# Service Memo

2019-001

Dispenser: Barista Professional (Best Foam)  
Title: Barista Professional payment in combination with telemetry

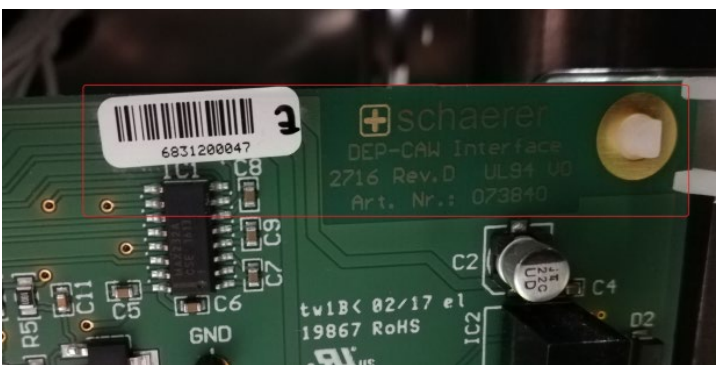
The Barista Professional machine with payment in combination with ATTO unit (telemetry) is only working with the BOARD INTERFACE DE-BP (073840) 55115646 from revision D onwards. In combination with PICO it works fine with older boards.

You can check the revision version on the board shown as below:

1. For machines produced before 06-2016 which has to be changed to an ATTO please check if the BOARD INTERFACE DE-BP is revision D or higher. If not first change board.
2. For machines produced after 06-2016 and up to week 32 2018 BOARD INTERFACE DE-BP revision D or higher should be in but by changing to ATTO please also check.
3. For machines produce after week 32 2018 revision D or higher is in.(serial number 1833.....)
